NUMBER:	08-025-17
GROUP:	Electrical

Headlamp Condensation And Fogging

This bulletin involves installing updated vent caps on the headlamp housing.

Jeep Grand Cherokee

Fig. 3 Location Of Headlamp Vents

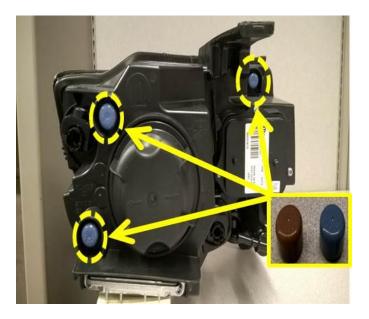
Blue vent caps are the old style. Updated vent caps are brown in color.

- 2. Remove the 3 blue vent caps by sliding them rearward from the headlamp assembly, see (Fig. 3).
- 3. Install the new (brown) vent caps by pressing them on the bosses of the housing.
